# UNITED STATES PATENT AND TRADEMARK OFFICE

10/551,735

<b>Office Action Summary</b>	<b>Application No.</b> 10/551,735	<b>Applicant(s)</b> TEARNEY ET AL.	
	<b>Examiner</b> Samuel A. Turner	<b>Art Unit</b> 2877

## DETAILED ACTION

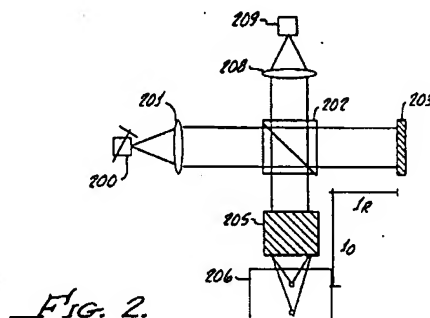
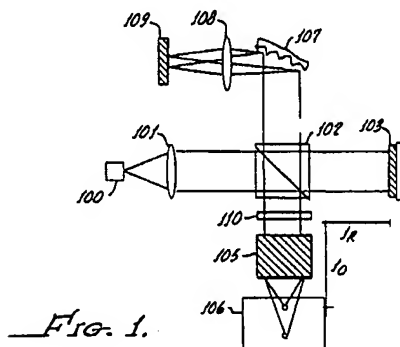
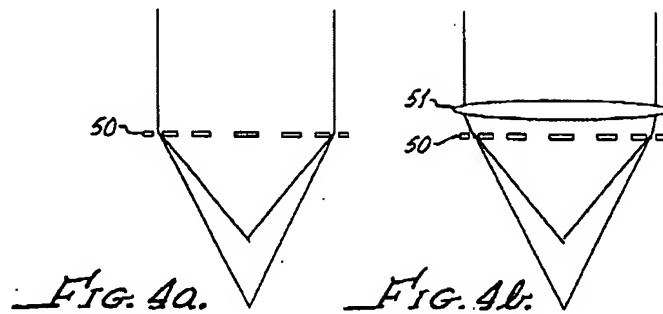
Claims 1-4, 7-10, 21-24, and 26 are rejected under 35 U.S.C. § 102(b) as being clearly anticipated by Knüttel(5,565,986).

With regard to claim 1, Knüttel teaches an apparatus for irradiating a sample(Fig. 1), comprising:

- a) an interferometer forwarding an electromagnetic radiation(Fig. 1); and
- b) a sample arm receiving the electromagnetic radiation(Fig. 1, 1<sub>0</sub>), the sample arm including an arrangement(Fig. 1, 105) which facilitates a production of at least two radiations from the electromagnetic radiation so as to irradiate the sample, the arrangement being configured to delay a first radiation of the at least two radiations with respect to a second radiation of the at least two radiations(by the difference in pathlength).

- c) a reference arm providing a further electromagnetic radiation(Fig. 1, 1<sub>R</sub>), wherein the interferometer receives the first, second and further radiations, and forms a resultant signal based on the first, second and further radiations(Fig. 1, 109); and
- d) a processing arrangement(column 7, lines 11-63) generating a first image based on the first radiation and a second image based on the second radiation,

As to claim 8/2, wherein the sample is irradiated by the first irradiation at a first angle, wherein the sample is irradiated by the second radiation at a second angle, the first and second angles different from one another(Fig. 1, 105; the beam angle varies with depth).

As to claim 9/8, wherein the first and second angle are different from one another based on the delay and at least one of a phase and a incident angle of each of the first and second radiations(Fig. 1, 105; delay=pathlength and incident angle=wavelength).

As to claim 10/2, further comprising a detector which detects the first electromagnetic energy, and forwards the detected energy to the processing arrangement(Fig. 1, 109).

With regard to claim 24, Knüttel teaches an apparatus for imaging(Fig. 1), comprising:

a. a sample arm receiving an electromagnetic radiation(Fig. 1, 10), the sample arm including an arrangement which facilitates a production of at least two radiations from the electromagnetic radiation so as to irradiate a sample(Fig. 1, 105), the arrangement being configured to delay a first radiation of the at least two radiations with respect to a second radiation of the at least two radiations(by the difference in pathlength);

b. a device receiving the first and second radiations from the sample arm and at least one third radiation from a reference arm, wherein the first and second radiations interfere with the third radiation(Fig. 1; the interferometer);

c. at least one of spectral separating unit which separates spectrum of at least one of the first, second and third radiations into frequency components(Fig. 1, 107); and

d. at least one detection arrangement including a plurality of detectors, each detector capable of detecting at least a portion of at least one of the frequency components(Fig. 1, 109).

FIG. 23

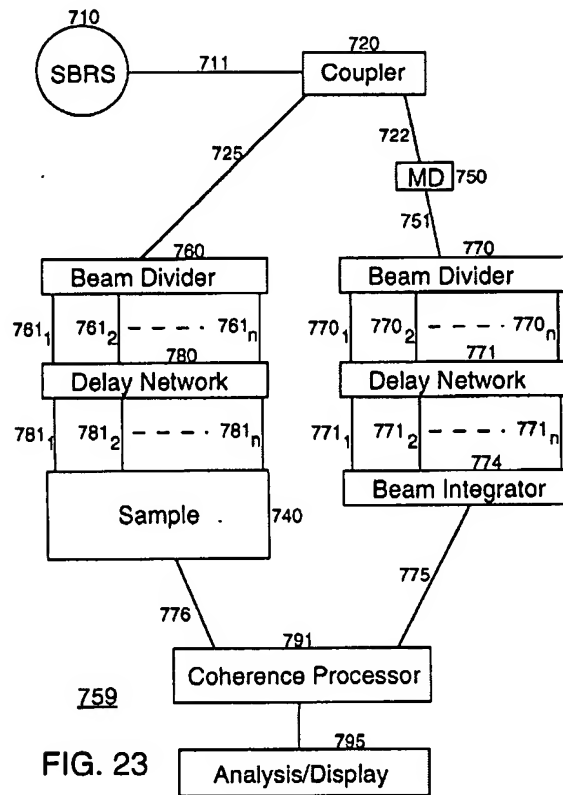
Claims 1-3, 7-11, and 21-23 are rejected under 35 U.S.C. § 102(b) as being clearly anticipated by Li(6,014,214).

With regard to claim 1, Li teaches an apparatus for irradiating a sample(Fig. 23), comprising:

a) an interferometer forwarding an electromagnetic radiation(Fig. 23, 759);  
and

b) a sample arm receiving the electromagnetic radiation(Fig. 23, 725), the sample arm including an arrangement(Fig. 23; 760,780) which facilitates a production of at least two radiations from the electromagnetic radiation so as to irradiate the sample, the arrangement being configured to delay a first radiation of

c) a reference arm providing a further electromagnetic radiation(Fig. 23, 722), wherein the interferometer receives the first, second and further radiations, and forms a resultant signal based on the first, second and further radiations(Fig. 23, 791); and

d) a processing arrangement(Fig. 23, 795) generating a first image based on the first radiation and a second image based on the second radiation, wherein the first and second images are different from one another(column 27, line 49- column 28, line 10).

As to claim 9/8, wherein the first and second angle are different from one another based on the delay and at least one of a phase and a incident angle of each of the first and second radiations(Fig. 23; 760,780; column 27, lines 61-65).

As to claim 10/2, further comprising a detector which detects the first electromagnetic energy, and forwards the detected energy to the processing arrangement(Fig. 23, 791).

As to claim 11/1, wherein the arrangement includes two sections, each being configured to delay a respective one of the first and second radiations, and wherein a delay of the first radiation is greater than a delay of the second radiation(Fig. 23, 780).

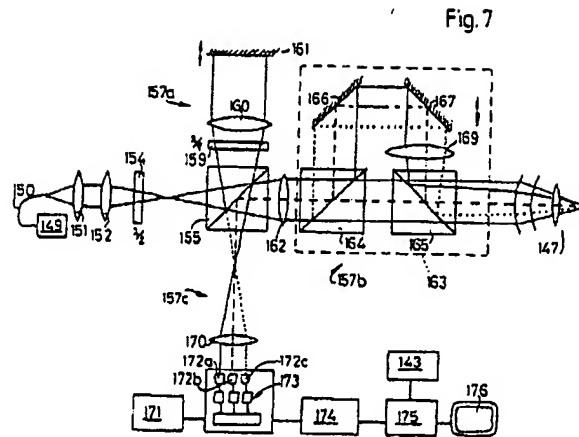
Claims 1-3, 7, 10, 11, and 21-23 are rejected under 35 U.S.C. § 102(b) as being clearly anticipated by Waelti et al(WO 01/38820, all references given below refer to the English translation U.S. 6,806,963).

With regard to claim 1, Waelti et al teach an apparatus for irradiating a sample(Fig. 7), comprising:

- a) an interferometer forwarding an electromagnetic radiation(Fig. 7); and
- b) a sample arm receiving the electromagnetic radiation(Fig. 7, 157b), the sample arm including an arrangement(Fig. 7, 163) which facilitates a production of at least two radiations from the electromagnetic radiation so as to irradiate the sample, the arrangement being configured to delay a first radiation of the at least two radiations with respect to a second radiation of the at least two radiations.

- c) a reference arm providing a further electromagnetic radiation(Fig. 7, 157a), wherein the interferometer receives the first, second and further radiations, and forms a resultant signal based on the first, second and further radiations(Fig. 7, 172); and
- d) a processing arrangement generating a first image based on the first radiation and a second image based on the second radiation, wherein the first and

As to claim 11/1, wherein the arrangement includes two sections, each being configured to delay a respective one of the first and second radiations, and wherein a delay of the first radiation is greater than a delay of the second radiation(Fig. 7, 163).
